SITE PLAN REVIEW AND APPEARANCE BOARD STAFF REPORT

1236 George Bush Blvd.

Meeting	File No.	Application Type
May 25, 2022	2022-014-SPF-SPR-CL5	Class V Site Plan Modification
Property Owner	Applicant	Agent
1236 George Bush Blvd LLC	1236 George Bush Blvd LLC	Thomas F Carney Jr.

Consideration of a Class V Site Plan, Landscape Plan, and Architectural Elevations for a proposed 6-unit townhome development located at 1236 George Bush Blvd.

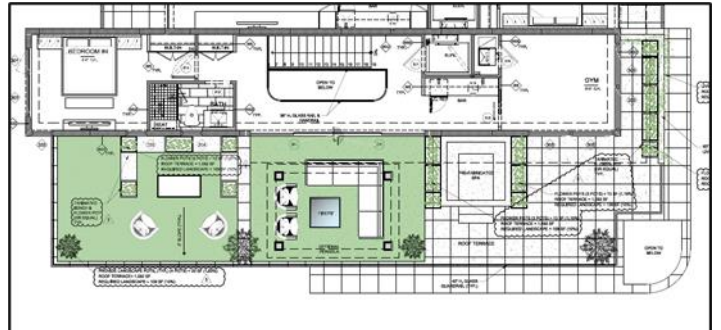
Rooftop landscaping is proposed. Pursuant to **LDR Section 4.3.3(RR)(3)(C)** *Rooftop use areas greater than 100 square feet and located below the maximum building height shall landscape a minimum of ten percent of the rooftop use area. Rooftop use areas that are located at the maximum building height shall landscape a minimum of 20 percent. Landscaping shall consist of trees, shrubs, ground cover, and vines.*

Roof top terraces are provided on the second floor, and are 1,092 SF. The applicant has provided 109 SF of landscaping, which includes living walls, planters, and pots (see the figure to the right).
